Re: 339 West Gorham Street: Oliv Madison

Attached is a minor amendment packet for the Oliv Madison Project. These changes address some program elements (expanded amenity), design refinements, and adding solar to the project. The packet illustrates the changes between the Original SIP document and the proposed amendments. The site plan review/building permit set elevations are also included for reference to show what was approved with the building permit.

UDC MINOR REVISIONS

OLIV MADISON 339 W GORHAM STREET

A46

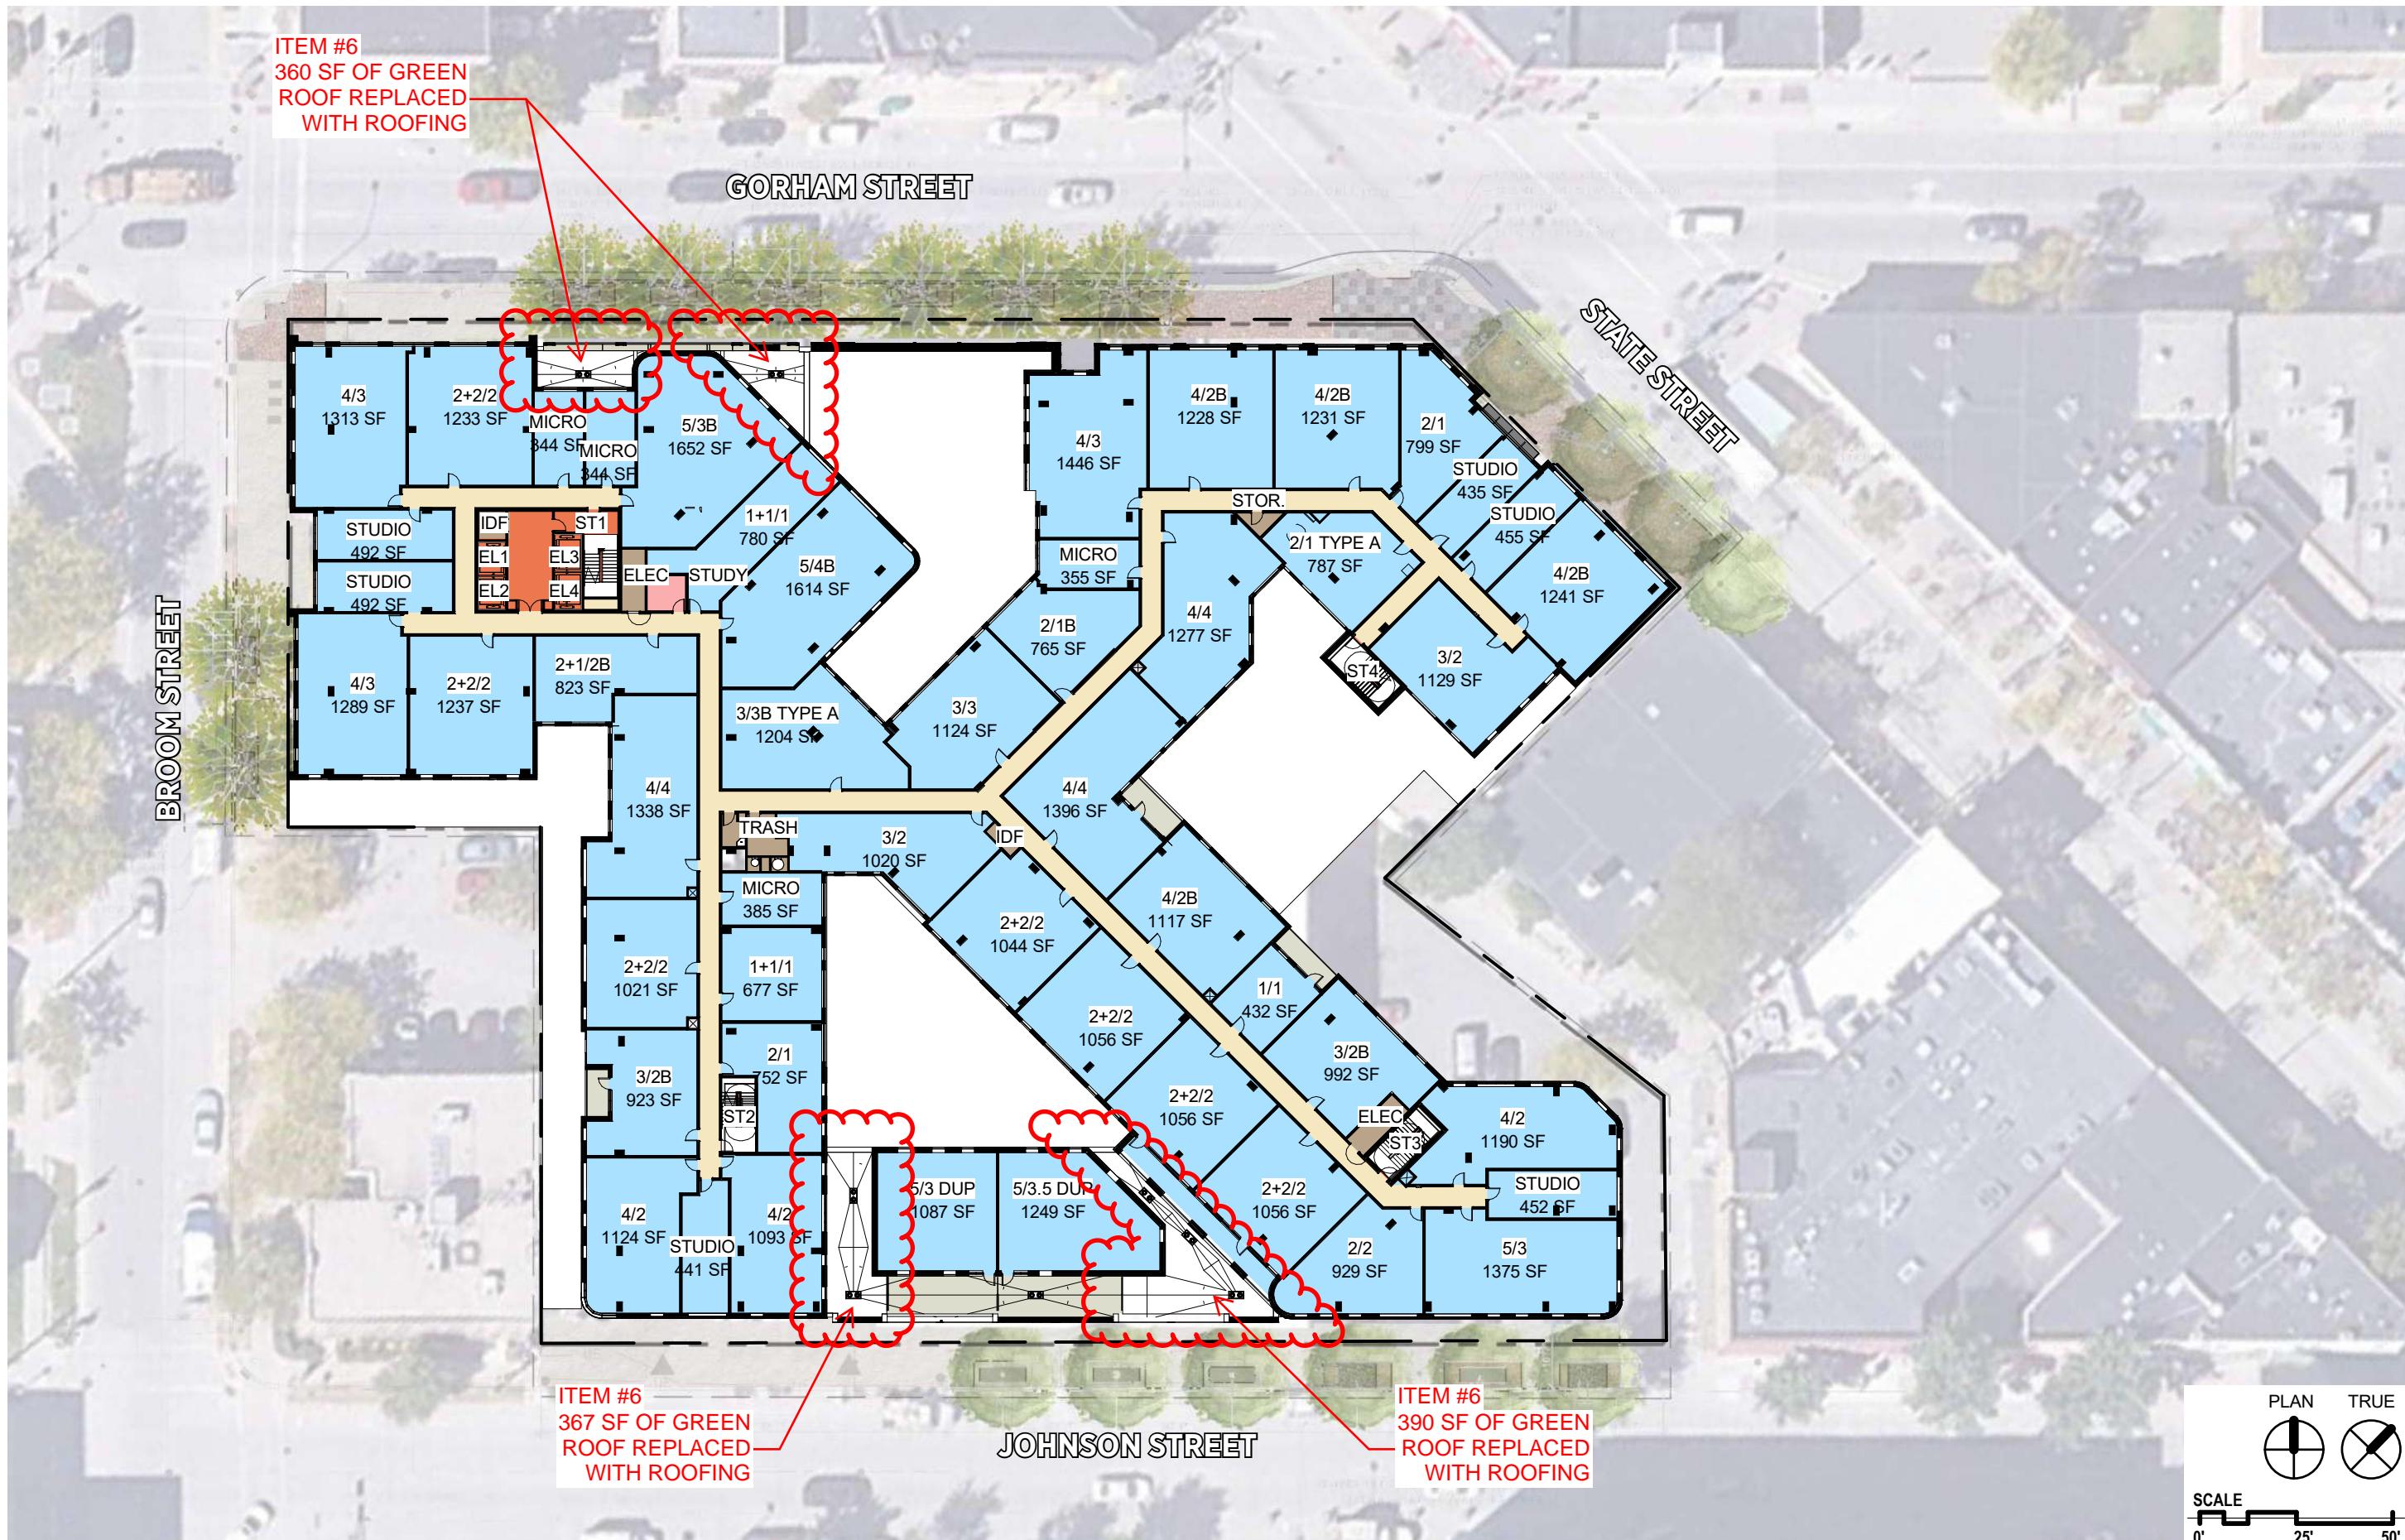
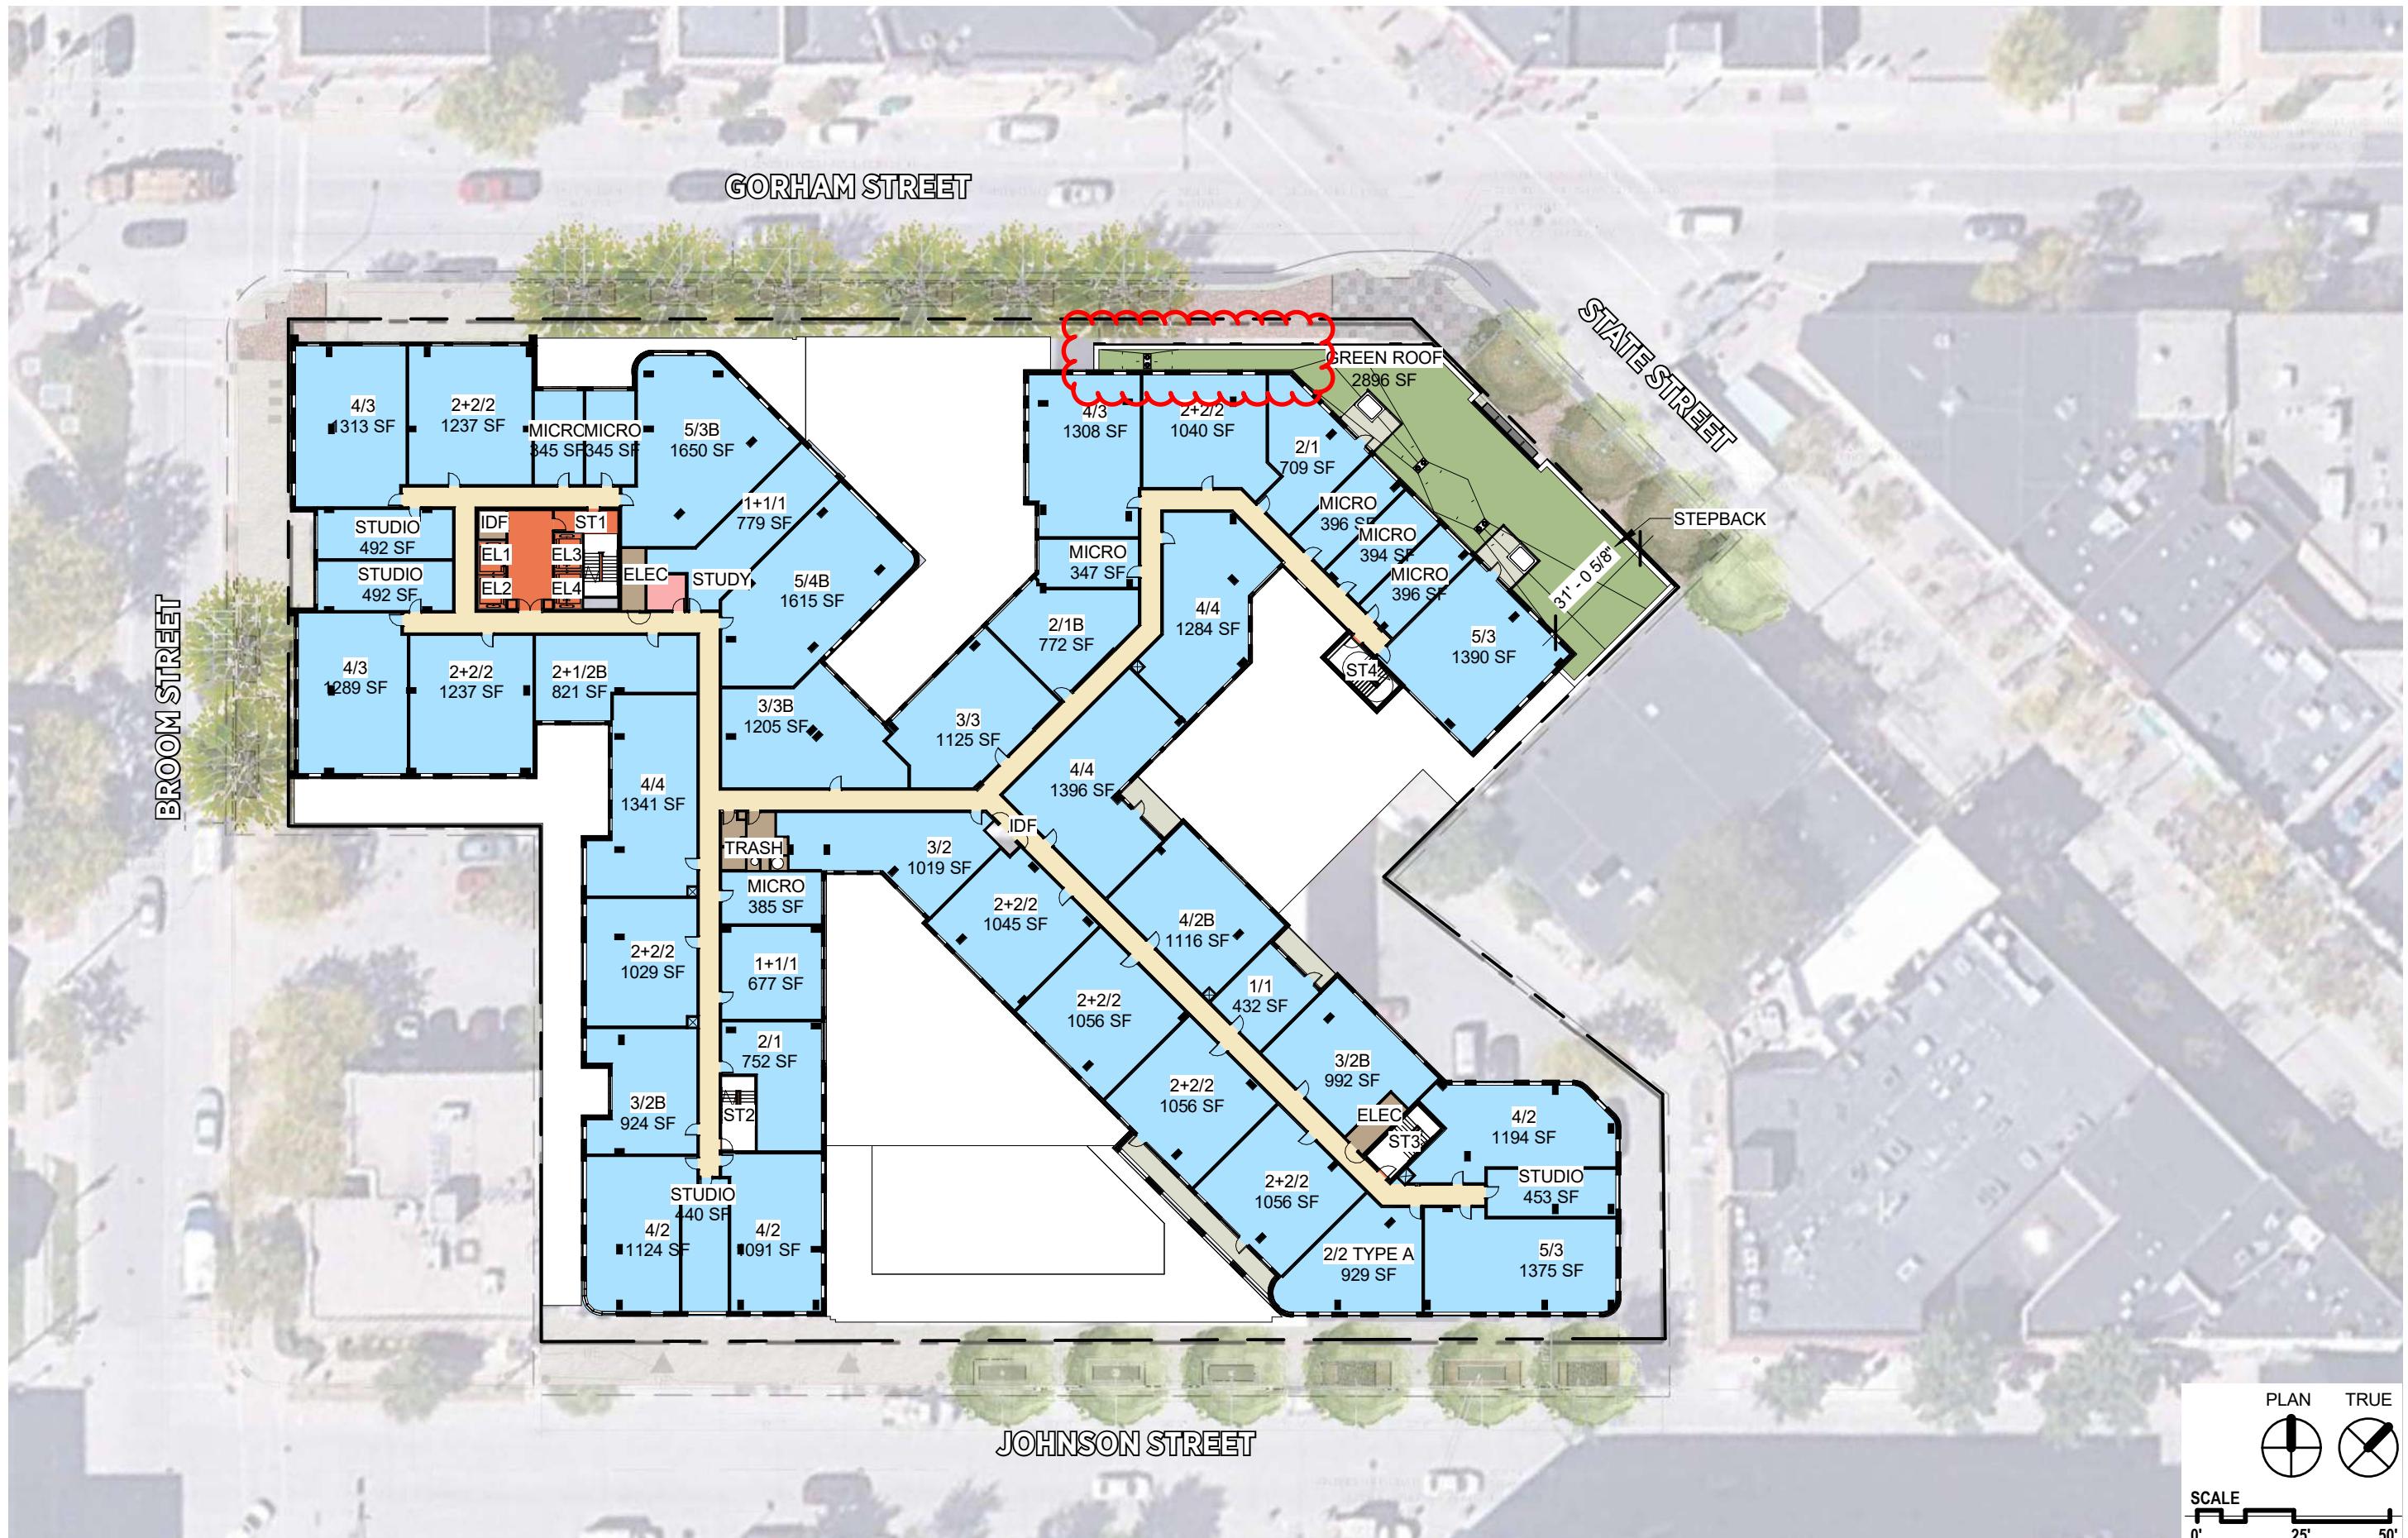
- Item 6. Added Solar Panels and green roof modifications (A45, A46, A47, A49, A51): Reduction of select green roofs for proper maintenance access. The areas deleted required maintenance access through tenant units. The removal of these select green roofs provides the financial ability to add solar panels on the roof. The project added 8,485 SF to dedicate to solar panels.

- i. Note on item 6: The project will still almost double the minimum green roof requirement for stormwater management. 6,600 SF was required. 14,209 SF was provided in approved set. The current proposal includes 11,613 SF of green roof.
